Access Compliance Report

Public Rights-of-Way

Intersection ID: 14213	Main Street: CENTRAL_AV	Cross Street: ROSEHAVEN_DR	Location: NW
ADA ID: 8F0C08F70D95	Ramp Type: BlendTrans1	Initial Pass/Fail: Fail	Overall Compliance: No
			Severity Score: 18.75

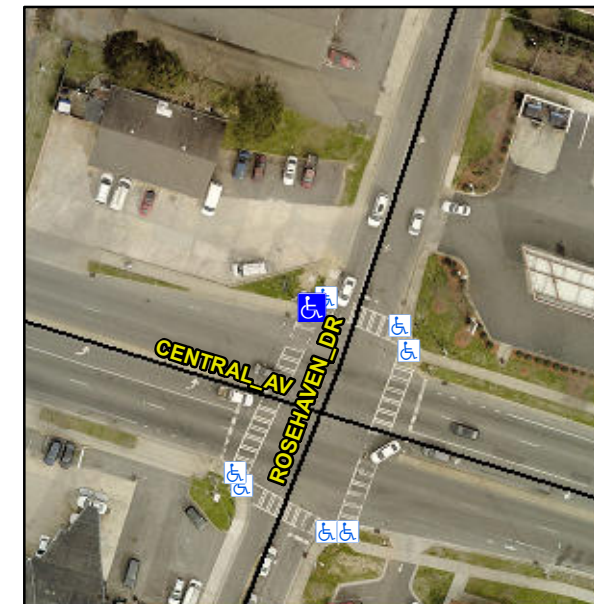
Not Found, R304.5.1, R304.5.3

Compliance	Description	Data	Compliance	Description	Data
N/A	Ramp Length (in)	73.0	Yes	BlendTrans Slope (%)	3.7
No	Ramp Width (in)	32.0	No	BlendTrans XSlope (%)	2.4
N/A	Flare Type LT	N/A	N/A	Flare Type RT	N/A
N/A	Flare Slope LT (%)	N/A	N/A	Flare Slope RT (%)	N/A
N/A	Flare Traversable LT?	N/A	N/A	Flare Traversable RT?	N/A
N/A	Landing Length (in)	N/A	N/A	DWS Provided?	N/A
N/A	Landing Width (in)	N/A	N/A	DWS Contrast?	N/A
N/A	Landing Slope (%)	N/A	N/A	DWS Length (in)	N/A
N/A	Landing X Slope (%)	N/A	N/A	DWS Full Width?	N/A
N/A	Landing Curb? (Y/N)	N/A	N/A	DWS Offset (in)	N/A
N/A	Shared Landing?	N/A			
N/A	Gutter Ponding?	N/A	N/A	Gutter Slope (%)	N/A
N/A	Gutter Lip Ht (in)	N/A	N/A	Gutter X Slope (%)	N/A
N/A	Painted X Walk1?	Yes	N/A	Painted X Walk2?	N/A
	X Walk 1 Direction	To SW		X Walk 2 Direction	N/A
	X Walk 1 Width (in)	105.0		X Walk 2 Width (in)	N/A
	X Walk 1 Slope (%)	0.3		X Walk 2 Slope (%)	N/A
	X Walk 1 X Slope (%)	2.3		X Walk 2 X Slope (%)	N/A

N/A	Ramp inside XWalk1?	Yes	N/A	Ramp inside XWalk2?	N/A
	Road Slope (%)	2.3		Clear Space?	N/A
	Road X Slope (%)	0.3	N/A	Clear Space to XWalk (in)	N/A
N/A	Any Obstructions?	N/A	N/A	Storm Grate/Utility Hazard?	N/A
	Obstruction Type			Storm Grate/Utility Type	
		N/A			N/A
			Yes	Surface Condition? (G/P)	Good
			No	Curb Slope (%)	21.0

Remove & Replace Curb Ramp With Two New Directional Ramps or Equivalent.
